AGENDA
Cascade Charter Township Planning Commission
Monday, July 17, 2017
7:00 pm
Cascade Library Wisner Center
2870 Jacksmith Ave. SE

TO: Cascade Charter Township Planning Commission
FROM: Steve Peterson, Community development Director
REPORT DATE: July 3, 2017
MEETING DATE: July 17, 2017
CASE: #17-3389 / Waterfall Shoppes

To: Cascade Charter Township Planning Commission
From: Steve Peterson, Community Development Director
Subject: #17-3363/Christian Brothers Automotive – Meijer PUD Amendments
Meeting date: July 17, 2017

PROJECT: **Waterfall Shoppes pylon 1-2**

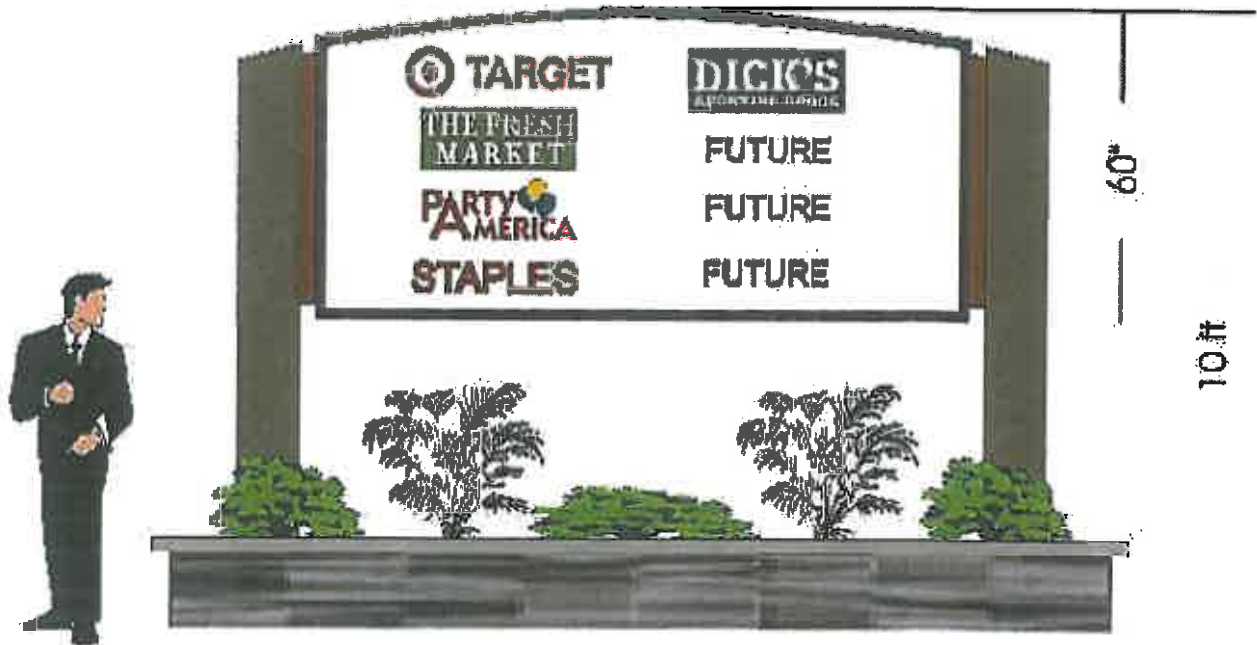
This change being requested not would allow an increase in the 95 sq ft sign to 120 sq ft. thus allowing a total of 275 sq ft in total for pylon signage.

The sign that they would like to expand has an existing real estate panel on it. this could easily be converted into advertising space

with no need to expand the sign. One commercial real estate sign per parcel is already permitted and could be done to accommodate the change to the pylon sign.

The change being request now would reduce the size of one of these large interior monument signs to 50 sq ft instead of 100 sq ft.

Deny the request for the additional pylon signage. The additional signage is contrary to the original intent of the PUD agreement by increasing signage out by the road and decreasing the internal signage. The existing pylon can be converted to advertising space with the removal of the real estate sign. I would look more favorable on a request that increases wall signage or interior signage than I would on pylon signage.
